Subject: Repair/Replacement of Missing or Altered Storefronts

- Applicable Standards:**
- 2. Retention of Historic Character
 - 6. Repair/Replacement of Deteriorated or Missing Features Based on Evidence
 - 9. Compatible New Additions/Alterations

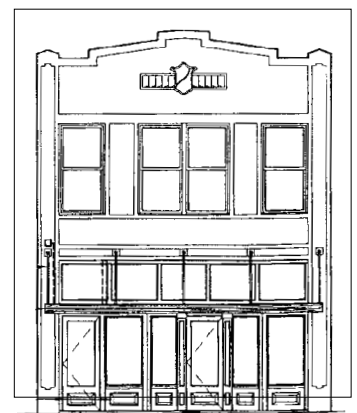
Application 3 (*Incompatible treatment later modified to meet the Standards*): This small, two-story brick building, originally constructed in 1889 as a newspaper office, had been “modernized” with an aluminum storefront installed in the 1950s. Although no historic photographs were found to show the building's original appearance, the storefront still had two entrances, one on the left leading to the upstairs, and another leading to the newspaper offices on the first floor. As part of a recent project to rehabilitate the building as a sports bar with apartments upstairs, a new, varnished wood storefront had been installed along with a very large awning that concealed the still extant, historic transom above the storefront. This new storefront was incompatible in scale, proportion, color and finish with the character of the historic building.

The storefront of this 1889 building was altered in the 1950s (left). The replacement storefront and awning were incompatible in scale, proportion, color and finish with the historic building (center). Remedial work to make the new storefront compatible will include re-installing a horizontal metal awning, painting the wood, and increasing the glass to wood ratio of the storefront (right).

Remedial work was proposed to bring the storefront into compliance with the Standards. The proportions of the storefront were corrected by lowering the height of the bulkhead panels and lengthening the glass in the display windows and the entrance doors. A traditional metal horizontal awning suspended from the facade would be installed which would once again reveal the transom. And, the new varnished wood of the storefront—the varnish already deteriorating rapidly on this west exposure, would be given a traditional painted finish, more appropriate to the character of the historic building and more protective of the wood.
